Review of Expert Panel Report Chapter 4--Context

William T. Holmes
Structural Engineer
San Francisco

Panel Report Chapter 4

Figure 4.4 (a) Estimated acceleration response – 4 September 2010

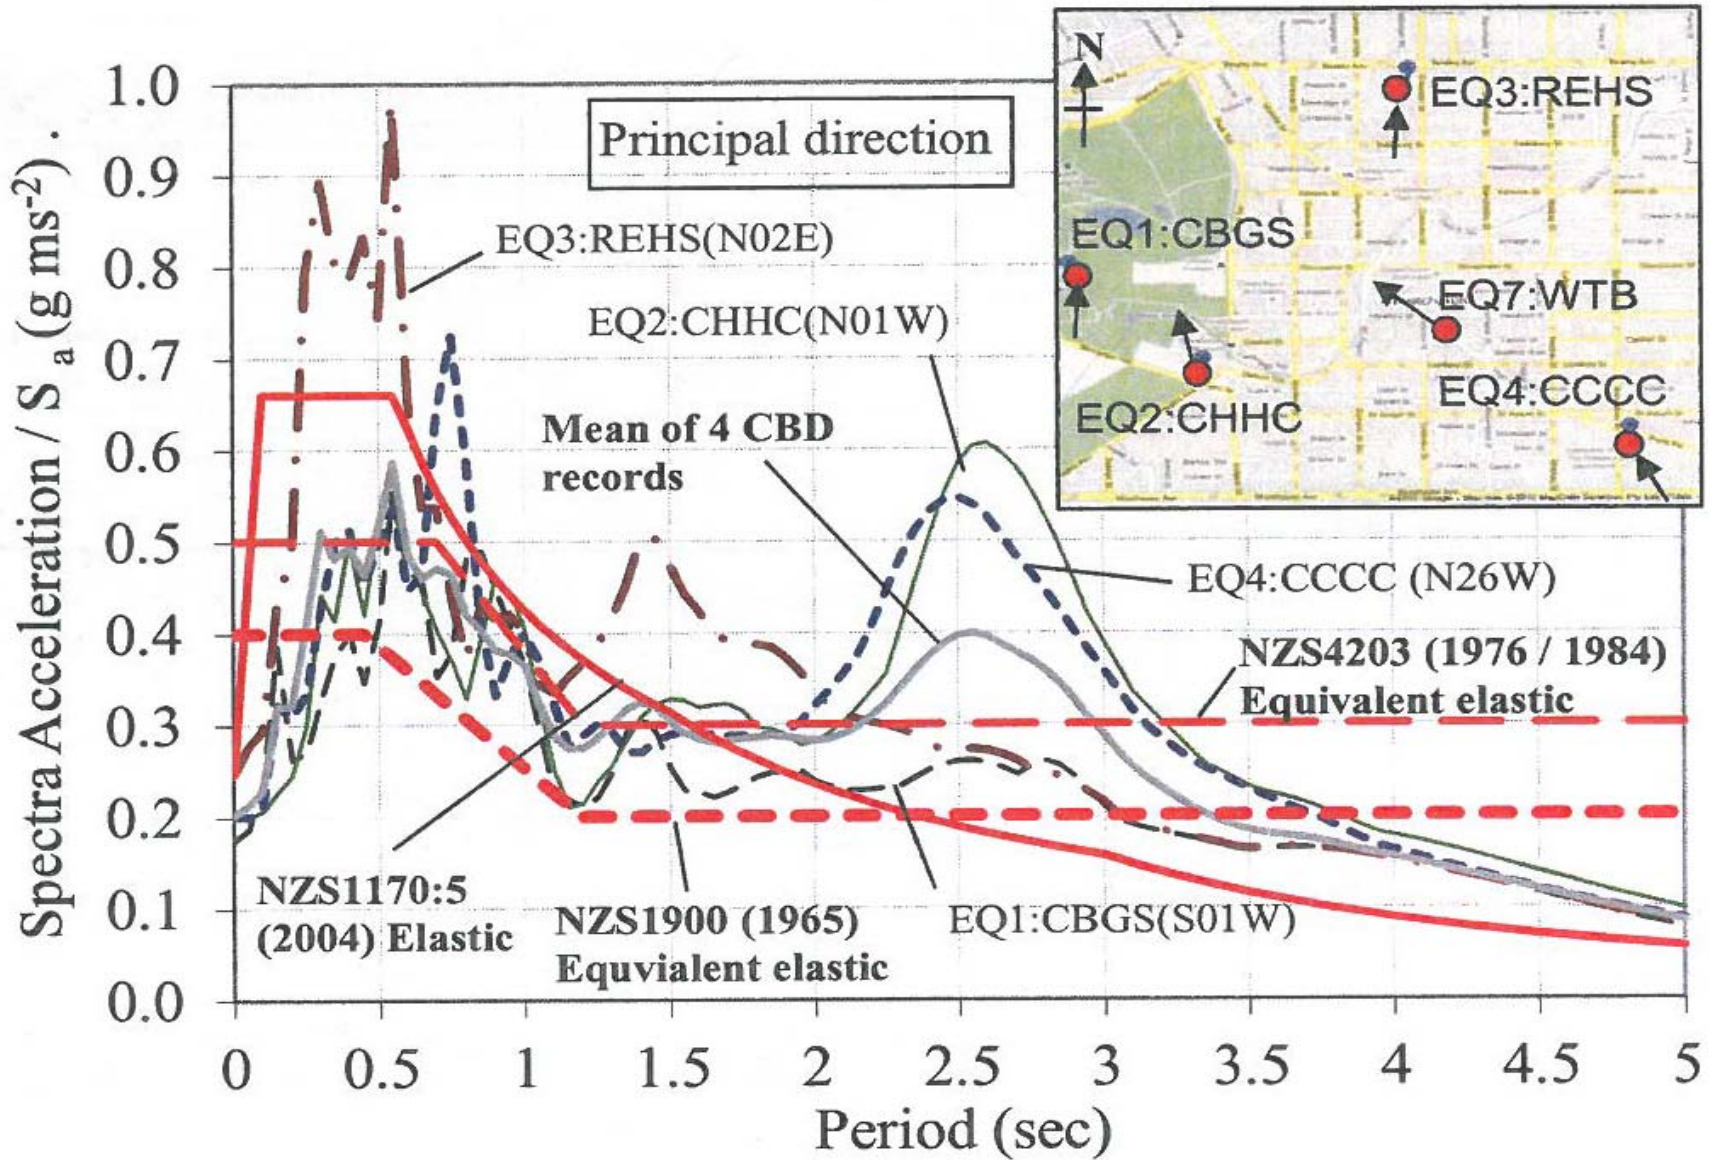
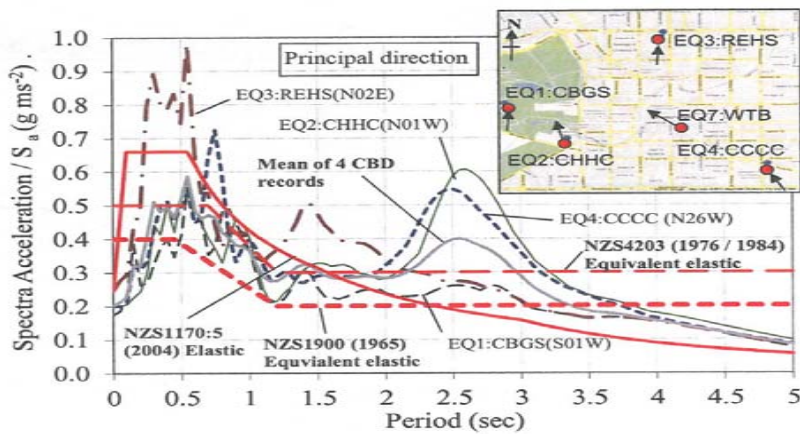
4.4a and 4.4b drawn to same scale
